SERVICE BULLETIN

SUBJECT: BATTERYS NOT CHARGING
Affected Models: Three Cylinder Models
Effective Engine No.: Before E.#'s GT380-38764
Reference: GT550-27536 & GT750-33504

Bulletin No. 137
Date June 11th 1973
Page 1 2

DIFFERENCE IN APPEARANCE:

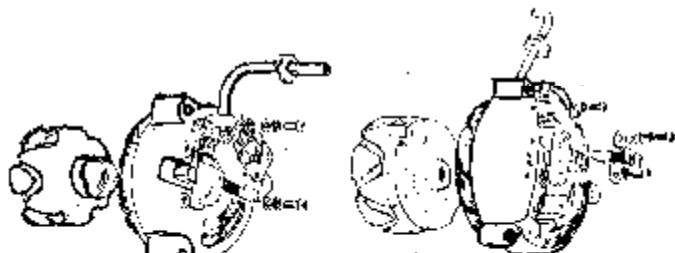
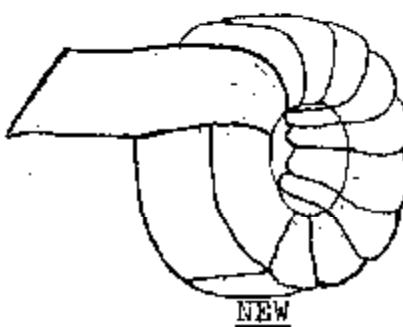
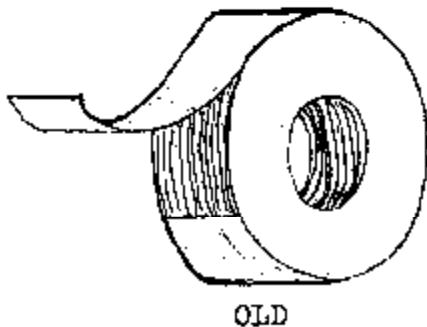
The early rotor coil was wound on a plastic bobbin then taped outside and fitted between the rotor poles with no space allowed for expansion of the coil windings when warm. The new type have their coil wound loose, then taped all around in the same manner as a new tire is wrapped. The coil is fitted with a felt spacer to allow the windings to expand and contract.
